[Docket No. 2002-SW-31-AD]

Airworthiness Directives; Model HH-1K, TH-1F, TH-1L, UH-1A, UH-1B, UH-1E, UH-1F, UH-1H, UH-1L, and UH-1P; and Southwest Florida Aviation Model SW204, SW204HP, SW205, and SW205A-1 Helicopters, Manufactured by Bell Helicopter Textron, Inc. (BHTI) for the Armed Forces of the United States

ACTION: Notice of proposed rulemaking (NPRM).

FIGURE 1

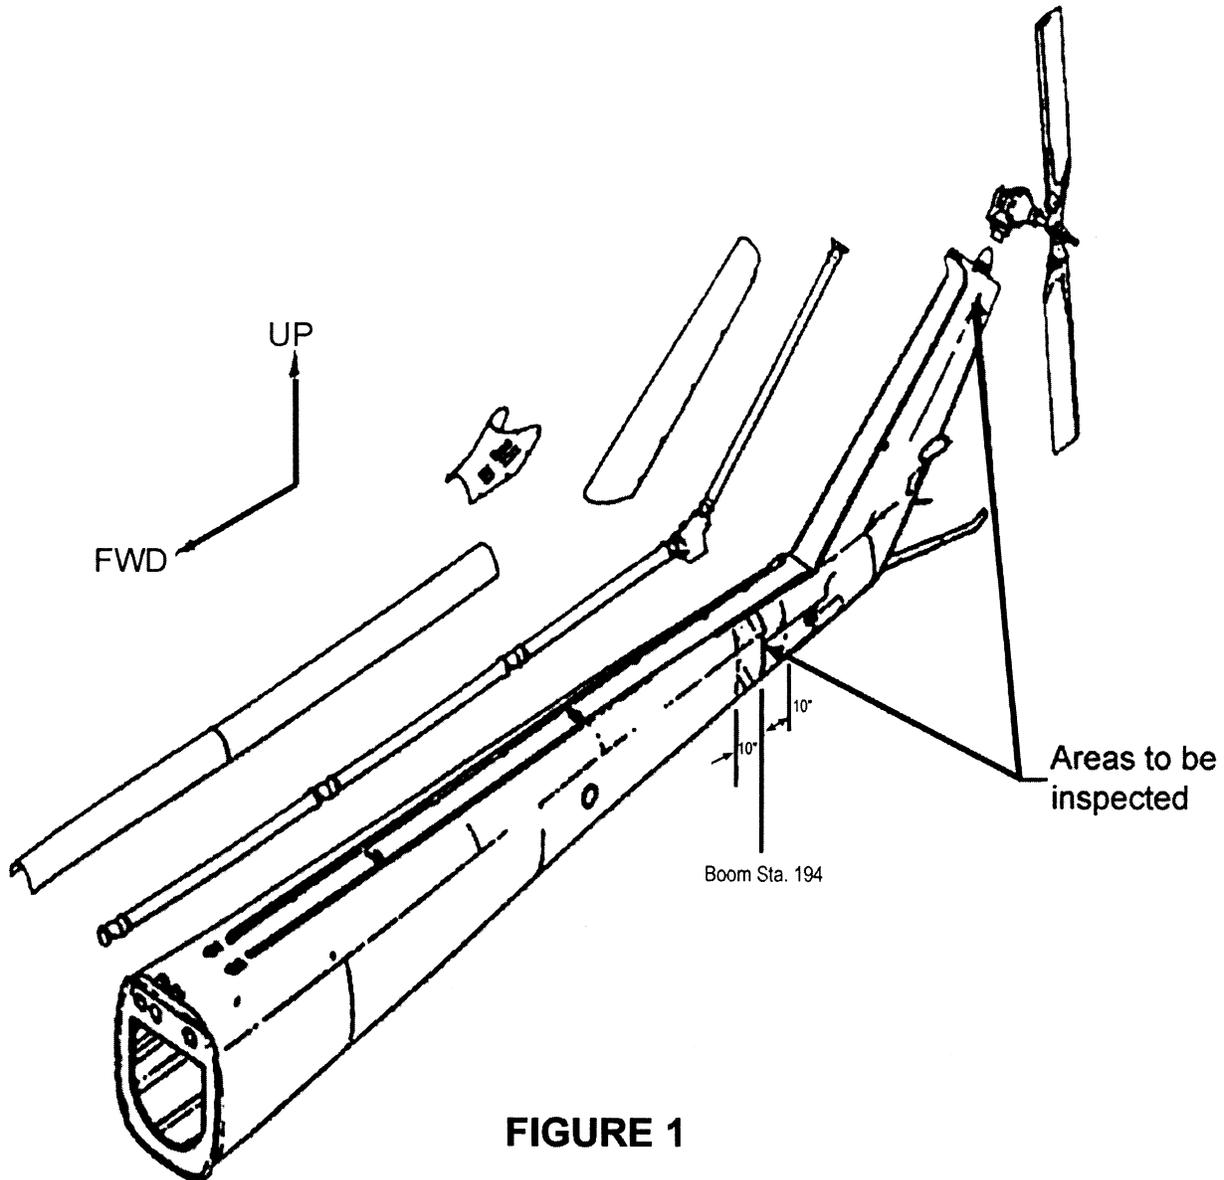
(1) Visually inspect the tailboom assembly skin joint at Boom Station (BS) 194 for fretting, corrosion, loose or working rivets, or a crack. Inspect 10 inches forward and 10 inches aft of BS 194 (BS 194 skin joint area) as shown in the following Figure 1:

Note 2: The tailboom skin joint at BS 194 is located at the bulkhead just forward of the attachment area for the 42-degree tail rotor gearbox assembly (42-degree gearbox) and the intersection between the vertical fin forward canted bulkhead and the lower tailboom skin.

(2) Visually inspect the vertical fin forward spar caps (2) for a crack at the intersection with the tail rotor gearbox support fitting. Refer to Figure 1 of this AD.

(b) Before further flight, and thereafter at intervals not to exceed 500 hours TIS, radiographically inspect the BS 194 skin joint area in accordance with the requirements of ASTM E 1742-00, MIL-STD-453C, or another FAA-accepted equivalent, for any tailboom assembly with:

(c) If a crack is found in any part, replace it with an airworthy part before further flight. Repair any corrosion or other damage that exceeds the limitations in the maintenance or overhaul manuals before further flight.
